STEPHANIE OAKS SUBDIVISION

APPLICATION NUMBER 6 DATE May 5, 2016

DETAIL SITE PLAN

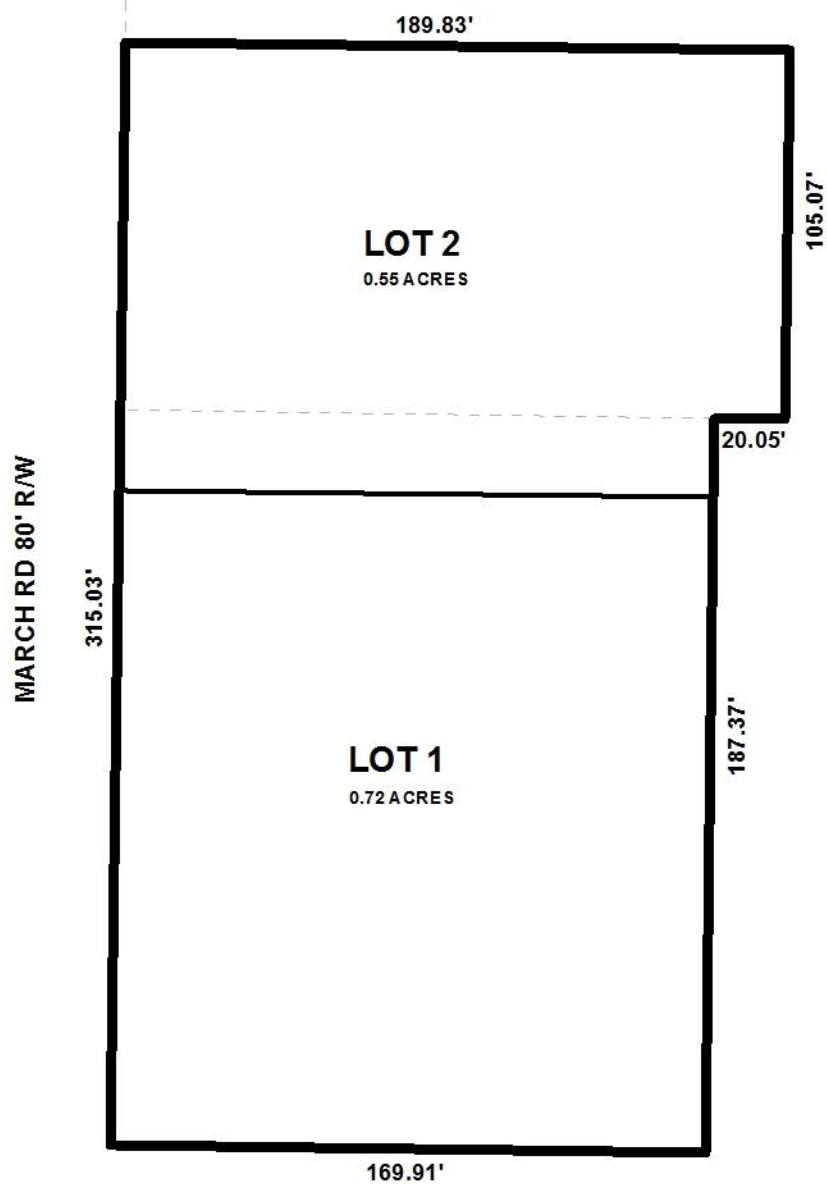
The proposed lots front March Road, a paved minor street without curb and gutter. As a paved minor street without curb and gutter, this street requires a 60' wide right-of-way width. The existing right-of-way width is depicted as 80' on the preliminary plat and should be retained on the Final Plat, if approved; thus, no dedication is required.

The 25-foot minimum building setback line is not indicated on the preliminary plat and should be revised on the Final Plat, if approved.

In accordance with Section V.D.2. of the Subdivision Regulations, the proposed lots exceed the 15,000 square foot minimum lot size requirement for lots served by public water and private sanitary sewer systems. The lot size information is depicted in both square feet and in acres on the preliminary plat and should be retained on the Final Plat, if approved.

As a means of access management, a note should be placed on the Final Plat, if approved, stating that both Lots 1 and 2 are each limited to the existing curb cuts to March Road, with the size, design and location of the curb-cut to be approved by Mobile County Engineering and conform to AASHTO standards.

- 1) Revision of the Final Plat to depict the 25-foot minimum building setback line for each lot;
- 2) Retention of the lot size information in both square and in acres on the Final Plat;

- 3) Placement of a note on the Final Plat stating that the proposed Lots 1 and 2 are each limited to the existing curb cuts to March Road, with the size, design and location of the curb-cut to be approved by Mobile County Engineering and conform to AASHTO standards;
